2019 November 19th

RE: Flood Mitigation - Sunnyside Berm Condition and Required Height

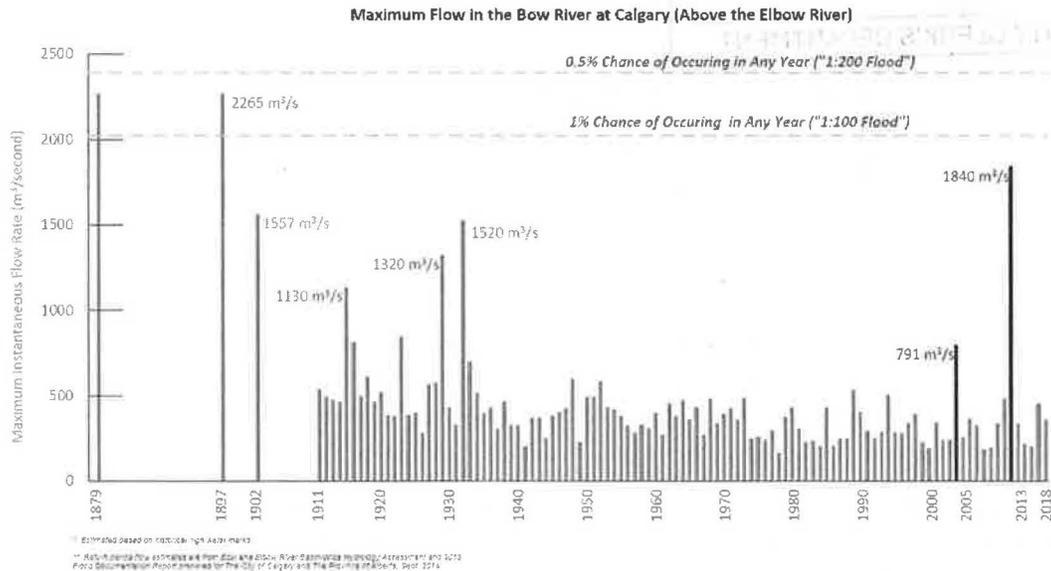
The historical map shows a 1 in 200 event occurred prior to the 1900's when measurements commenced. Who knows what flows went down the Bow in pre-measurement history?
